**Application for an Oil Sands Mine,
Bitumen Extraction Plant, and Bitumen Upgrading
Plant in the Fort McMurray Area**

January 27, 2004

**REPORT OF THE JOINT REVIEW PANEL ESTABLISHED BY THE
ALBERTA ENERGY AND UTILITIES BOARD AND THE GOVERNMENT OF CANADA**
EUB Decision 2004-005: Canadian Natural Resources Limited, Application for an Oil Sands Mine,
Bitumen Extraction Plant, and Bitumen Upgrading Plant in the Fort McMurray Area
January 27, 2004

Figure 1. Horizon oil sands project area

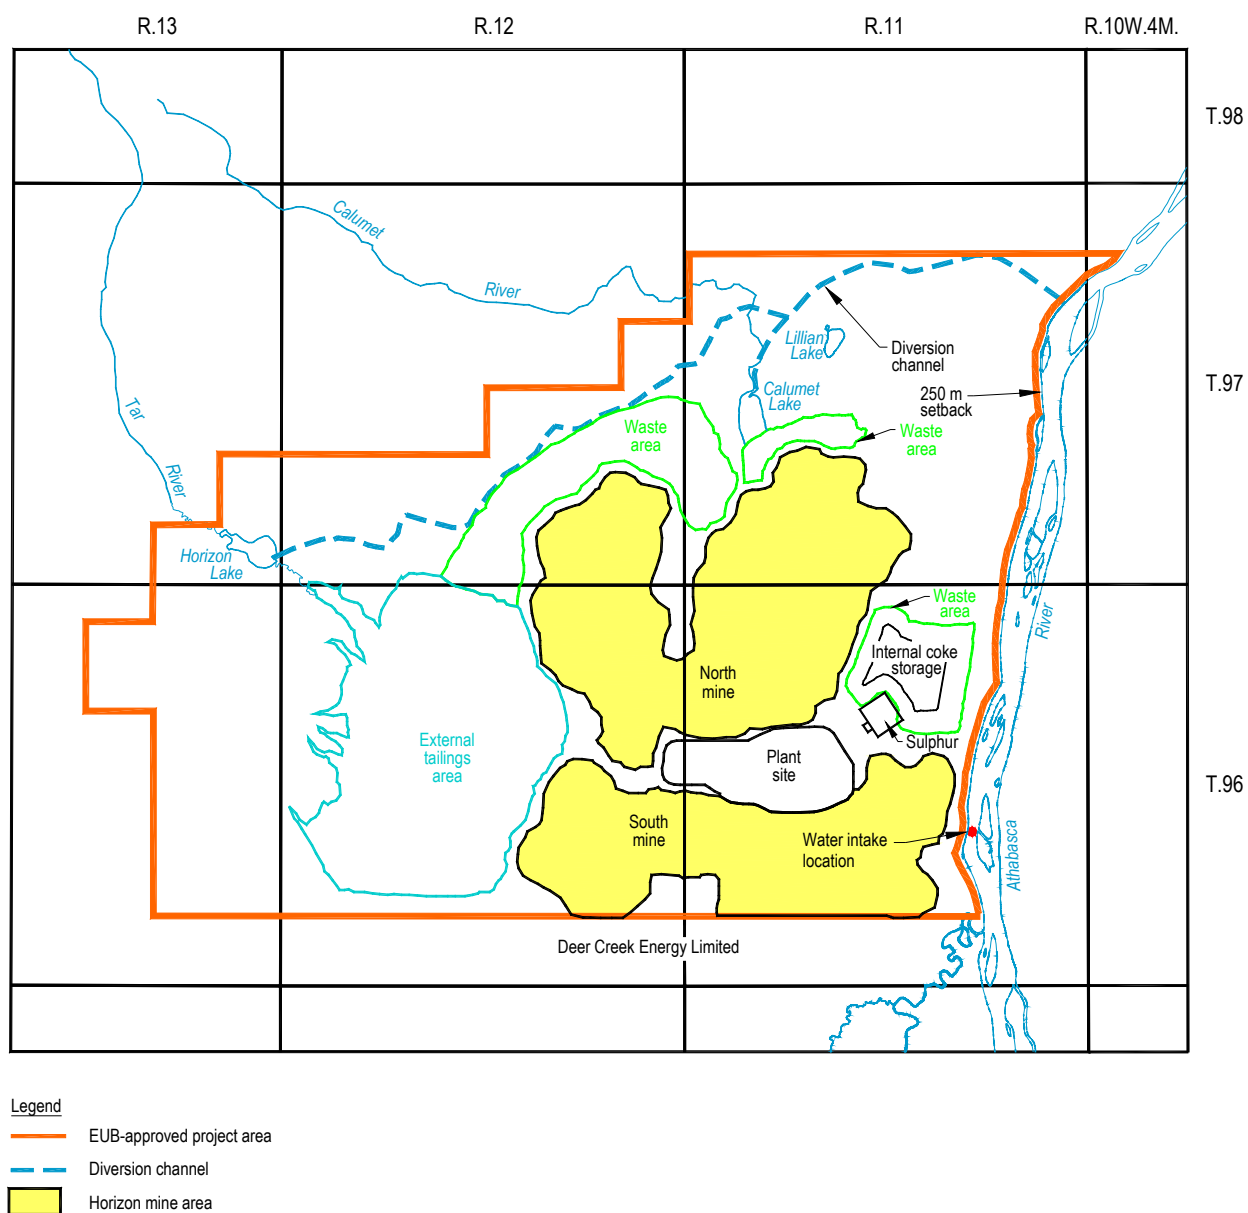
CNRL also indicated that the originally proposed plant site location was underlain by thick sequences of geotechnically weak Clearwater clay. CNRL stated that it performed additional geotechnical analyses to determine the feasibility of constructing a major bitumen upgrading facility at this location. The results indicated that the construction of such a facility upon this type of foundation was without precedent. CNRL also stated that it considered pile foundation costs to be prohibitive due to the volume of concrete required. CNRL further stated that pile foundation movements would pose a serious risk to the operation of heavy upgrading components, such as the cokers.

As a result of the concerns regarding foundation conditions, CNRL relocated its proposed plant site northward to the location shown on Figure 1. CNRL believed that the new plant site location would address the geotechnical concerns associated with the originally proposed site, since Clearwater clays were absent in portions of the new location. It recognized that construction of the plant in the new location would result in the sterilization of approximately $53.9 \times 10^6 \text{ m}^3$ of recoverable bitumen, $11.4 \times 10^6 \text{ m}^3$ more than the original site. However, CNRL indicated that its analysis showed that the additional costs associated with the original plant site exceeded the value of the additional foregone bitumen resources associated with the new plant site.

The Panel therefore finds that CNRL has justified the additional resource sterilization beneath the new plant site. Notwithstanding the overall acceptance of the proposed plant site, the Panel believes that since the layout of the plant site facilities remains to be finalized, some reduction in size may be realized through optimization of facilities. It therefore directs that six months prior to the construction of the plant site, CNRL shall submit a report to satisfy the EUB that all reasonable efforts have been made to optimize the plant site area with respect to the minimization of resource sterilization. The Panel notes that any additional oil sand sterilization resulting from an increase to the plant site area would require prior EUB approval.
